**PUBLIC HEARING
20 THAMES STREET**

RE: January 18, 2017 Public Hearing

Application for: Certificate of Appropriateness for New Construction

Addresses: 20 Thames Street

1 | South Elevation

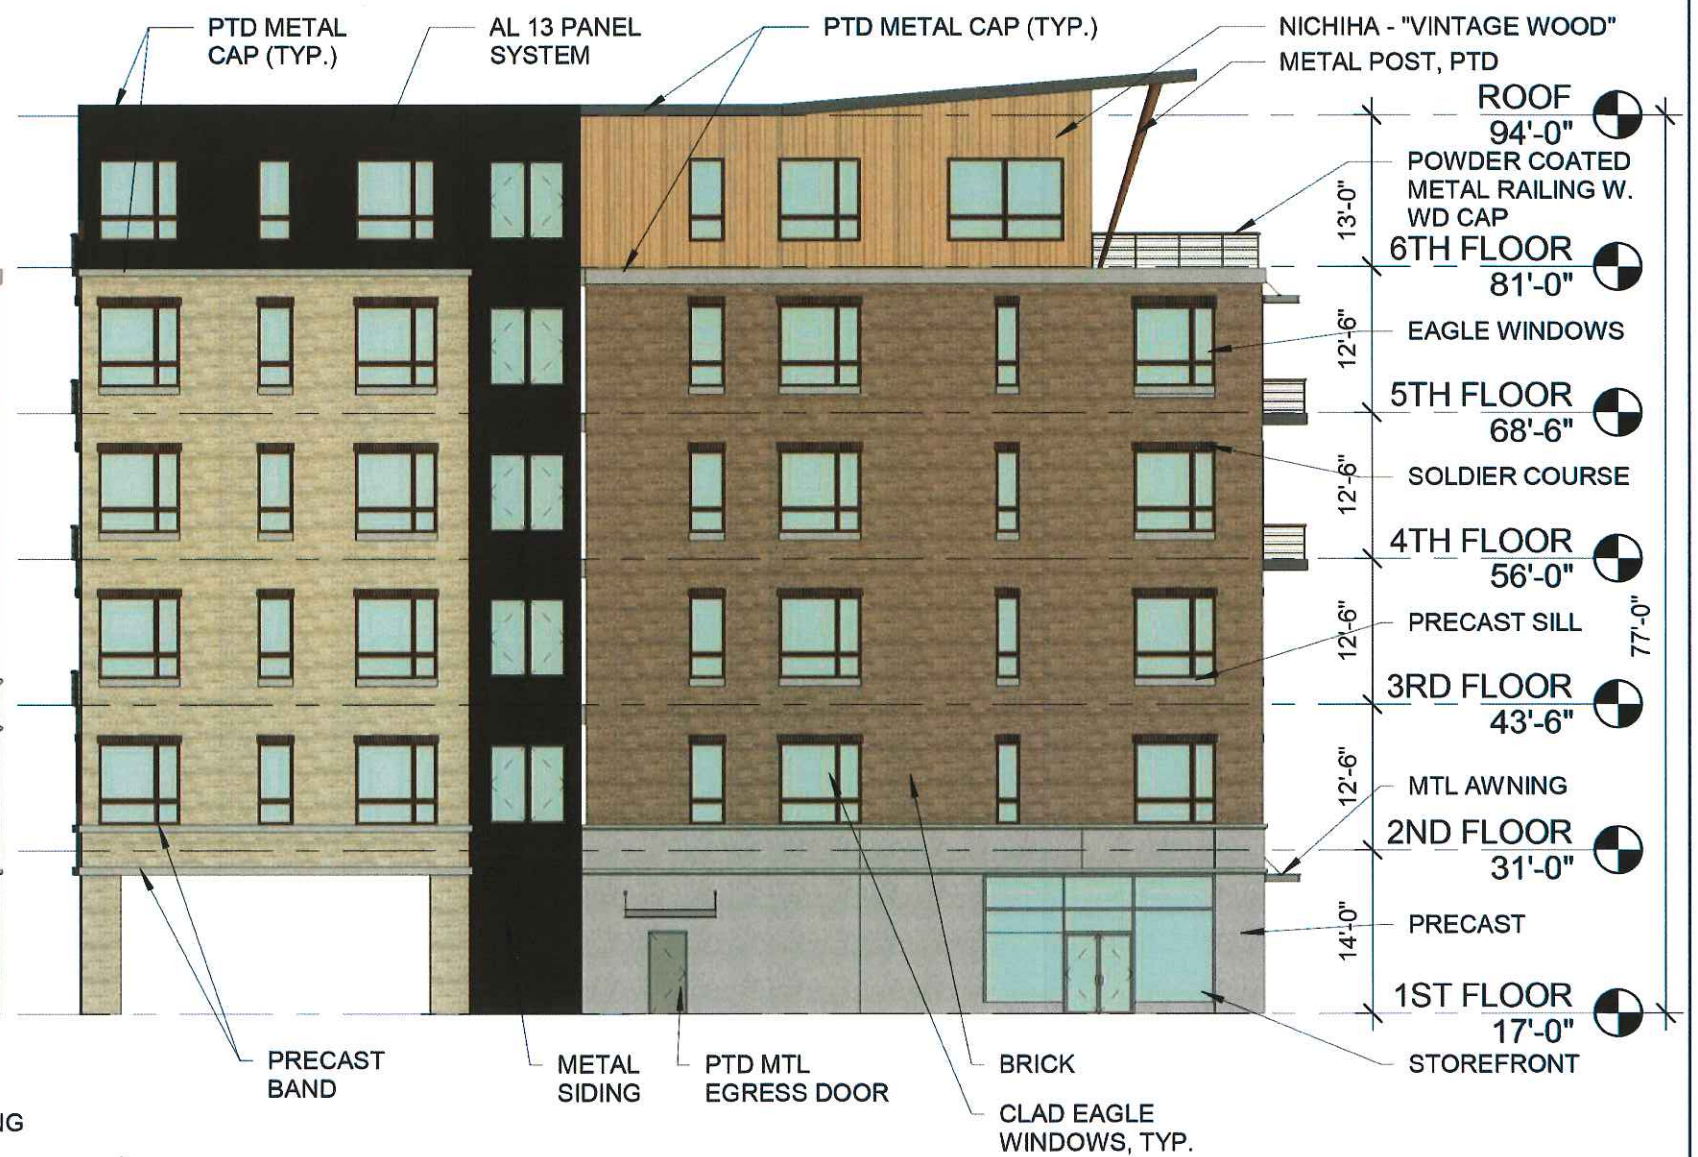
The floor-to-ceiling height of the top floor is shown as 13' tall (the residential floors below are 12'6"). The *apparent* height of the top floor, however, is considerably taller as viewed from Thames Street, as the roof structure pitches up toward the street. While the overall building height is calculated at 77 feet, the roof pitch adds another 4 feet to the height of the top floor as viewed from Thames Street.

The one aspect of the design that generated some comment was the height of the top floor as viewed from Thames Street. Some members of the Board suggested that the height be adjusted to be less exaggerated in relation to the height of other upper floors.

Mr. Lloyd has provided a list of design revisions made since the December 7 workshop—see ATTACHMENT 1. In the memo, he indicates that the upper roof has been lowered in response to Board comments. Given that no dimensions were provided with the previous submission, it is difficult to assess the degree to which this detail has been revised in the final submission. Based on the renderings, it does not appear to have changed significantly. The Board may wish to ask for clarification on the revision.

Two aspects of the final proposed design might warrant further consideration. Although staff understands that the pitched roof on the top floor has been adjusted to make the height of this floor less exaggerated, further adjustment might be appropriate. Staff also questions whether the proposed use of Nichiha—in a style and installation pattern that simulates vertical natural wood siding—is the most appropriate material selection in this context. While its use is very limited on the building's front façade, the material is more prominent on the side elevations.

1. The upper roof, south face looking out over the water has been lowered per boards comments.
2. The railing details on upper deck have been simplified and now detailed.
3. The northern elevations of the building are now defined with material, color and massing.
4. Area identified on roof for HVAC equipment.
5. Details for brick veneer, window sills and headers detailed.
6. Exterior materials all called out as brick, Precast, metal panels and Nichiha, please refer to elevations.

2 | West Elevation

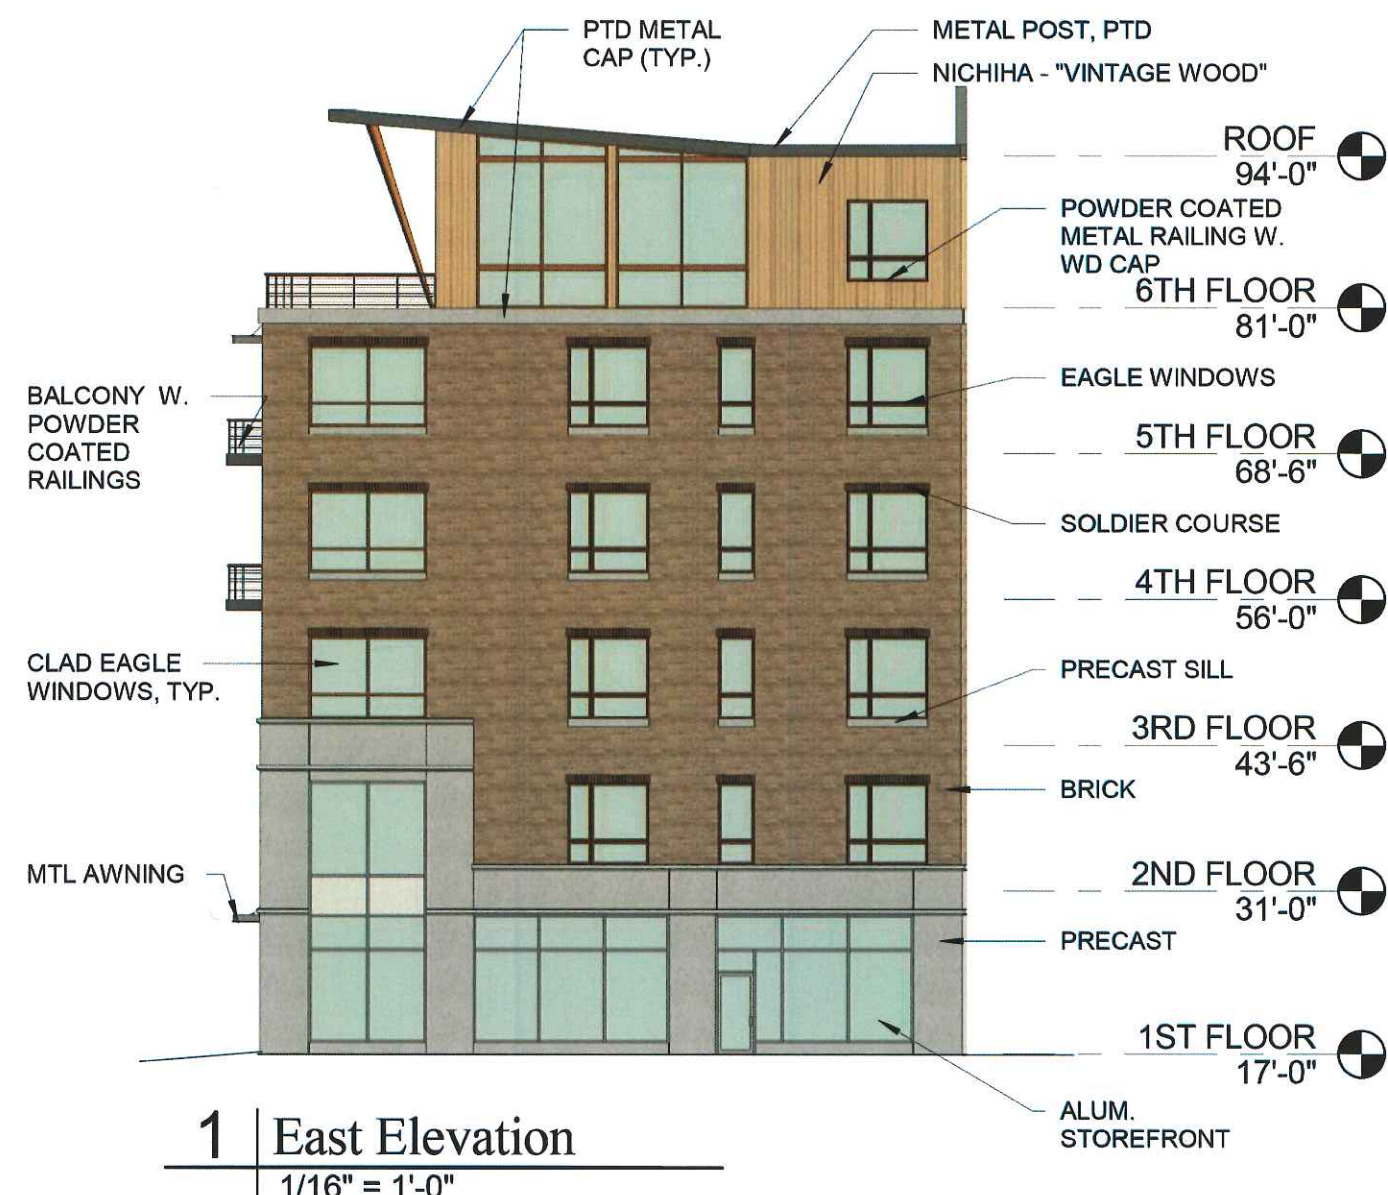
On the west elevation, next to the Grand Trunk Building, the defined building base and cement board siding on the top floor shown on the front façade return around the corner a considerable distance, providing a sense of depth and visual continuity with the front façade. From this point the west elevation transitions to metal siding, shown in a dark finish. This material serves as a narrow "hyphen" between the brown brick on the front portion of the building and the yellow brick on the rear. Note that the metal siding extends across the balance of the top floor. Alternating window types mark this elevation.

Although not included in Mr. Lloyd's list of design revisions, the west elevation of the building has been revised substantially. Where the original scheme showed the material palette of the Thames Street façade wrapping around the corner of the building for a short distance, the treatment now extends fully half the depth of the building.

1 | East Elevation

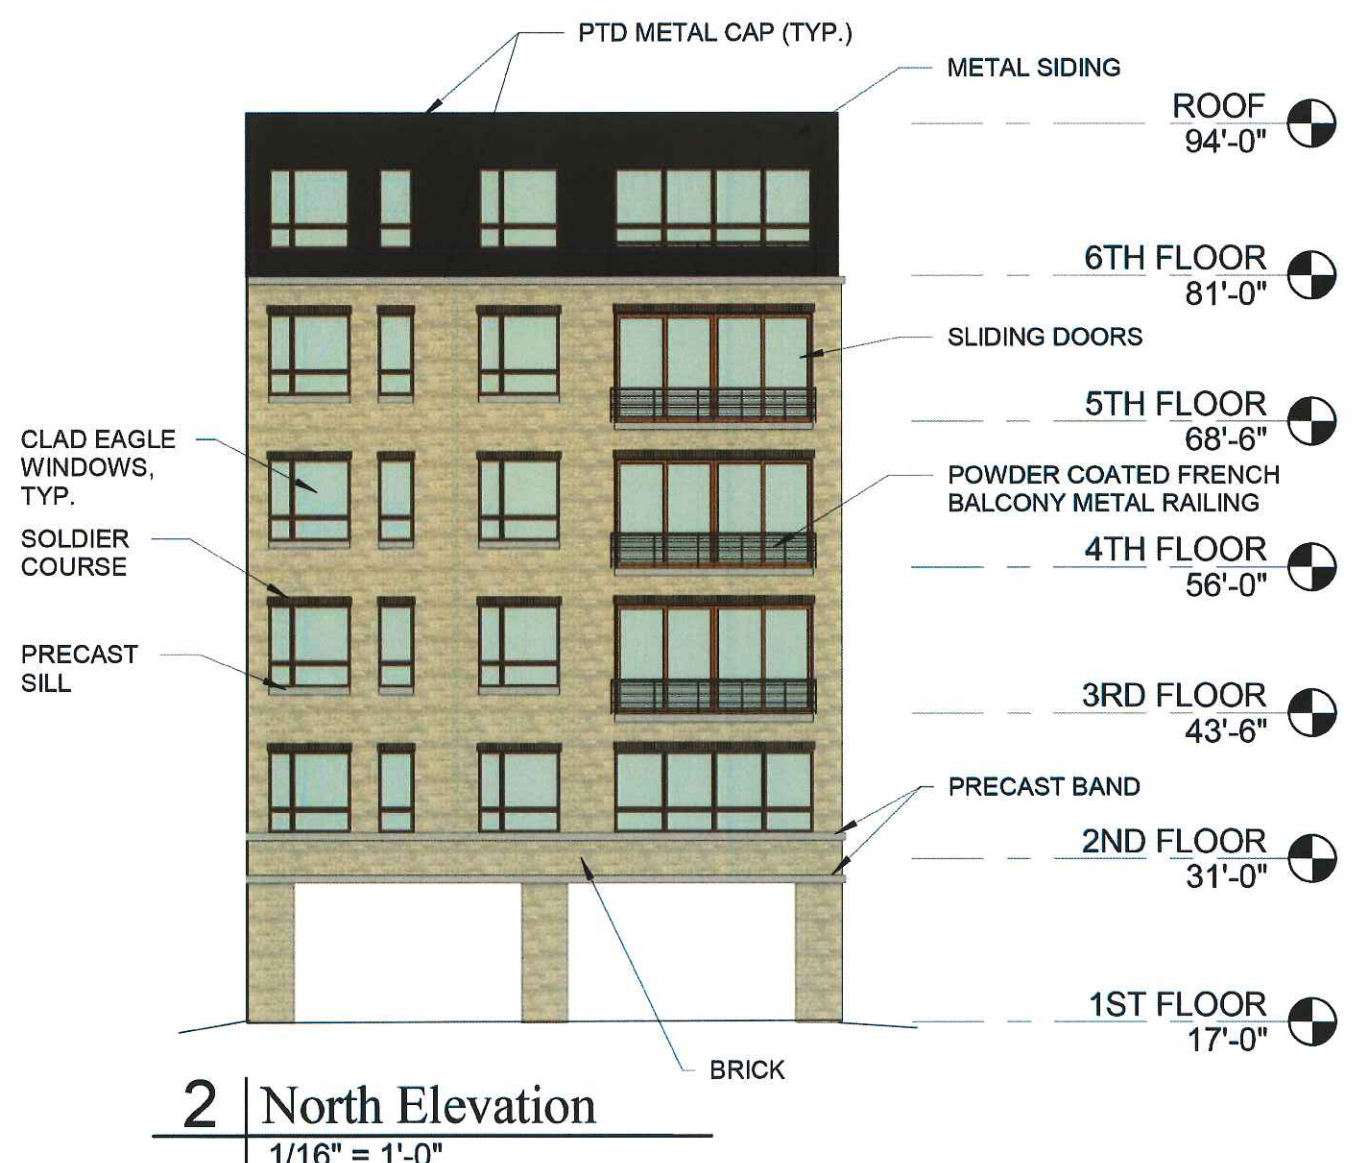
The east elevation, which faces the new hotel, repeats the building vocabulary established on the front façade. Note that the large windows at the top floor level continues for two bays on the east elevation.

2 | North Elevation

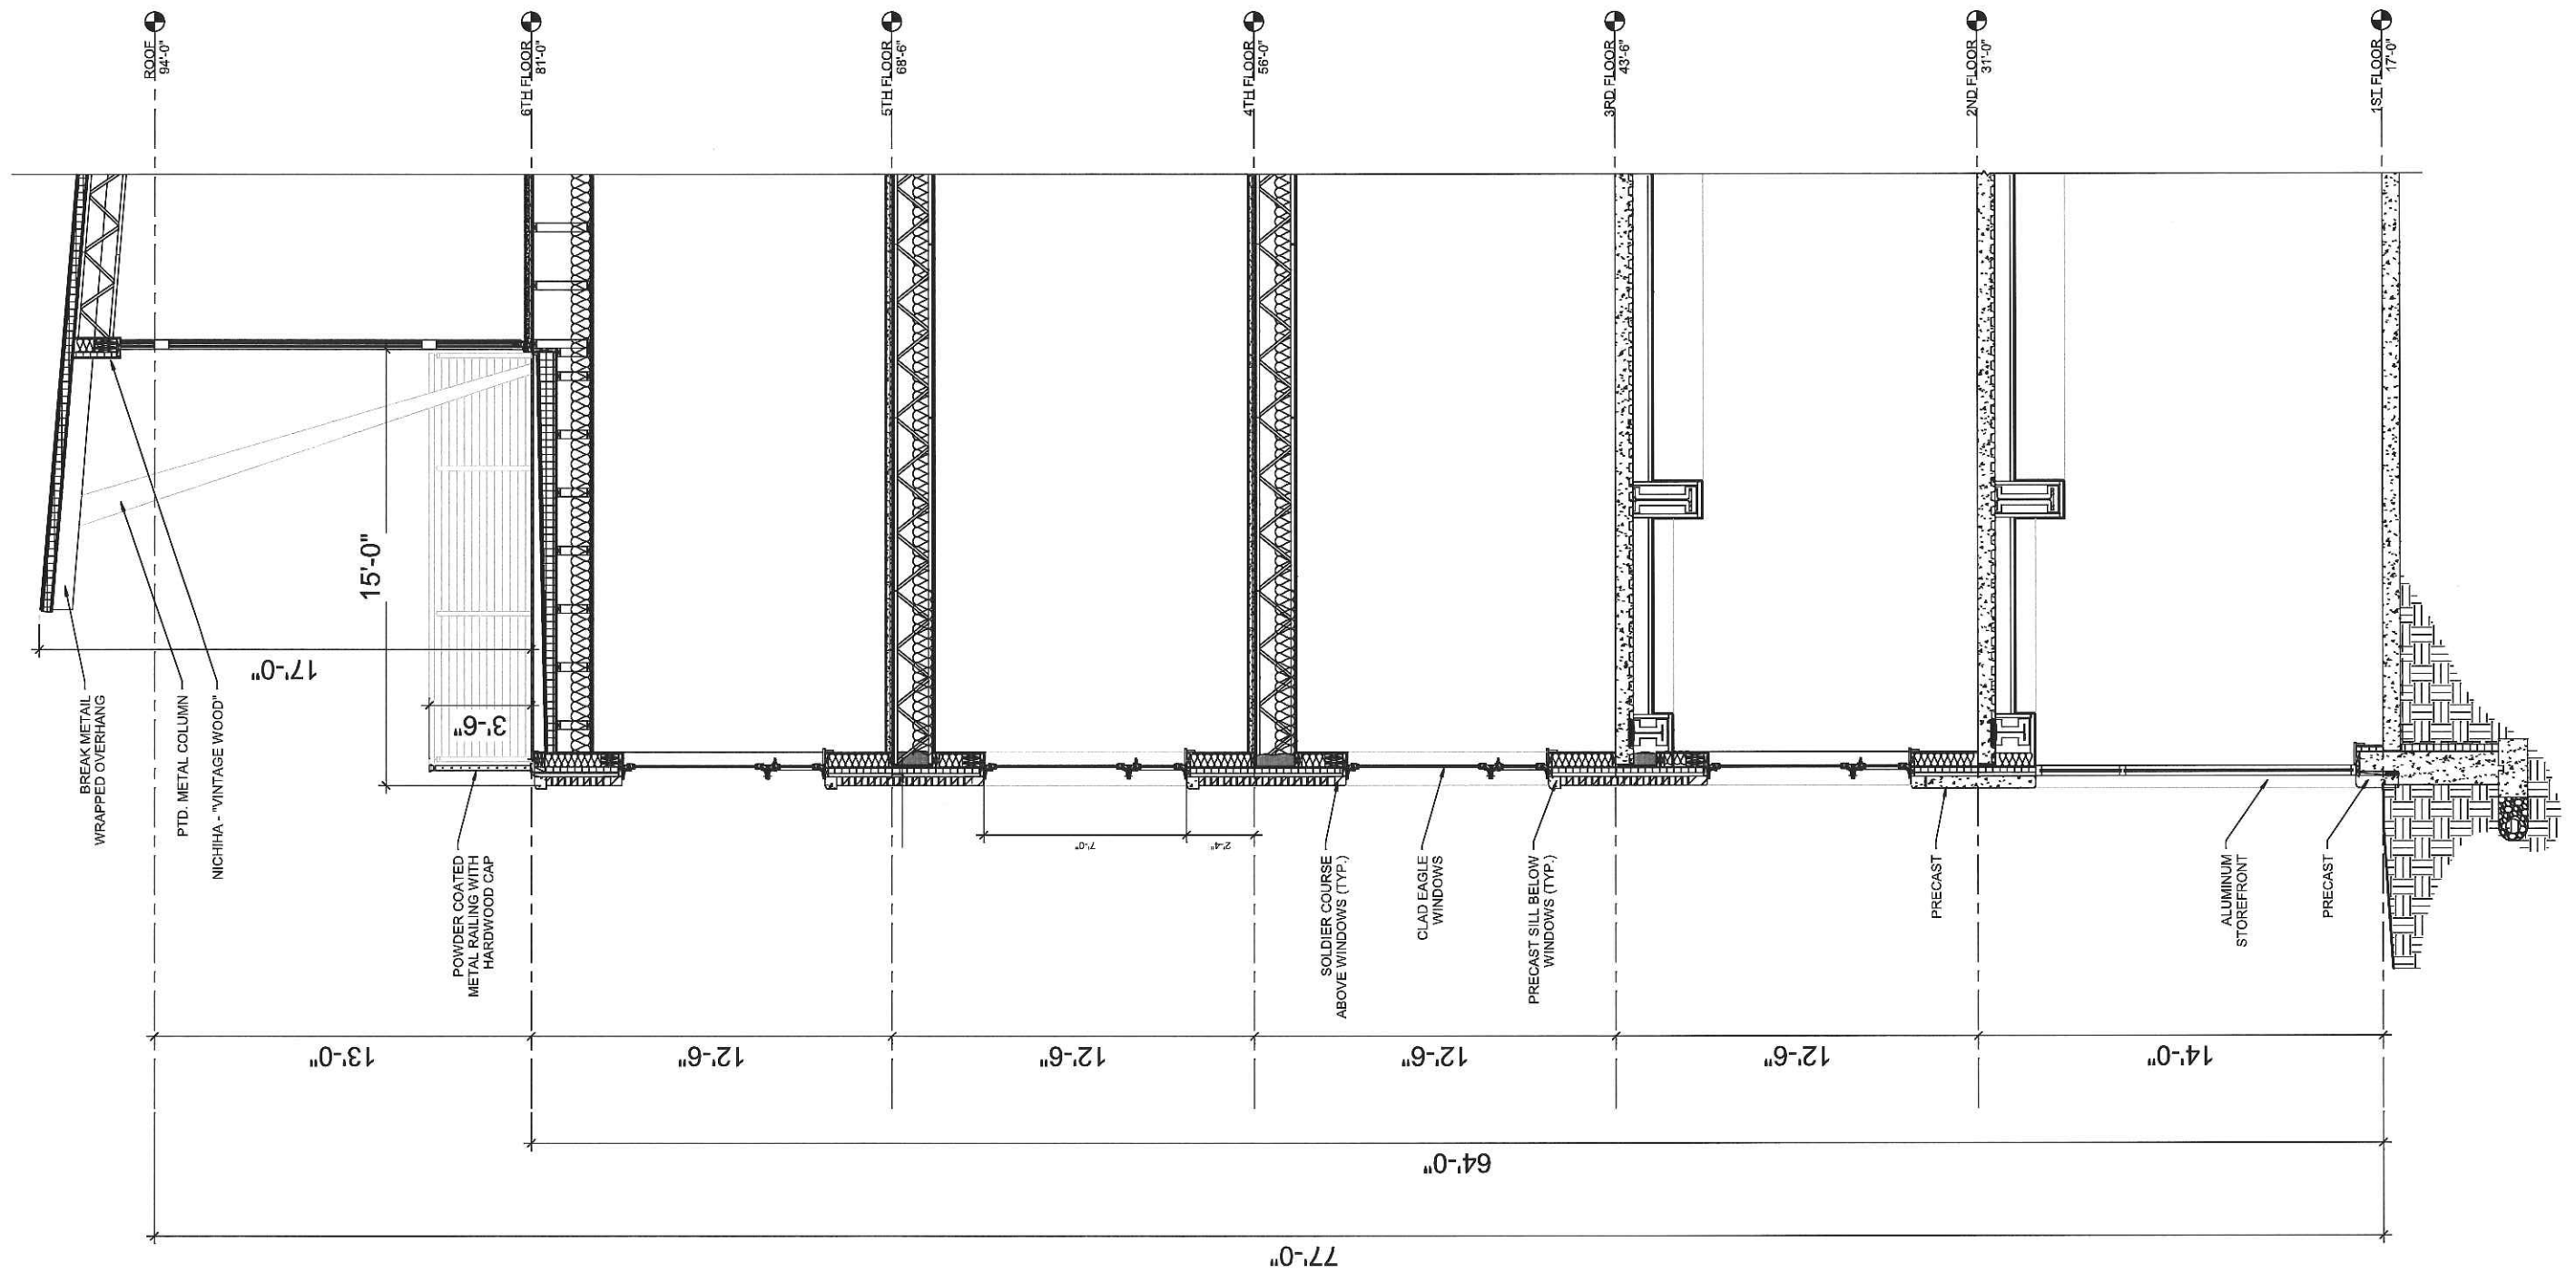
A depiction of the north elevation is provided with this submission, however the faceted concave wall facing the circular drive at the interior of the lot is not shown, however. As noted above, the north elevation is clad in yellow brick. This material choice is proposed to respond to the material palette of the hotel across the circular drive.

The enclosed submission includes all four building elevations. It does not, however, include an elevation of the concave wall facing the circular drive at the interior of the lot. The elevations are now annotated to show proposed building materials, window products, etc. A wall section for the Thames Street elevation is provided, as well as typical window details. Other details, such as those for the storefront canopies and the roof supports for the projecting canopy at the roofline have not been provided. While window and door specifications have not been provided, staff understands that material samples and specifications will be available at the meeting. Also, the proposed site treatment for the area between the Grand Trunk and new building is not shown in the submission. These will be needed for final approval.
